Urgent: Medical Device Correction
**Grip Cable Failures on da Vinci X and Xi Reusable Instruments with
Jaws (ISIFA2024-09-C)**

1- Introduction
and Reason for
Field Action

Figure F: Location of Part Number and Version on Instrument Box

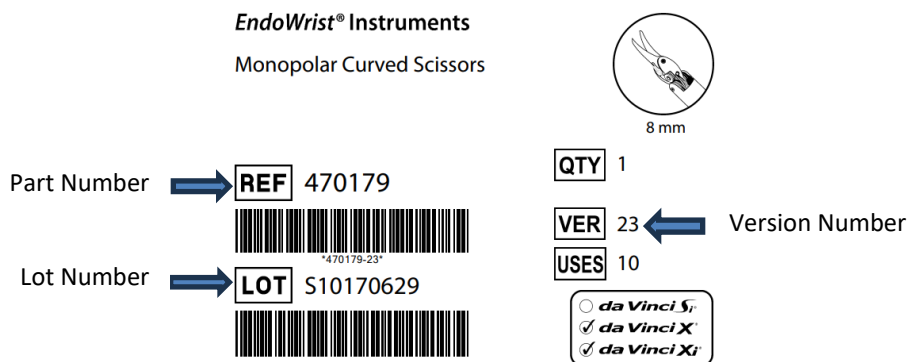
Please see photos below of where the version number is located on the instrument box (Figure F) as well as the instrument casing (Figure G).

Figure H: Broken Cable

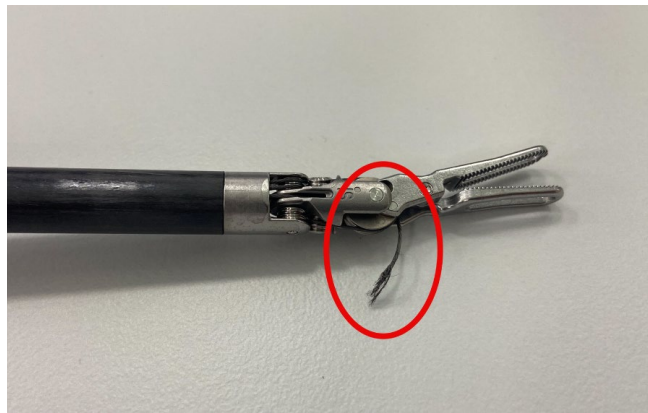
Prior to use, visually inspect all instruments for broken or frayed cable per Figures H & I below
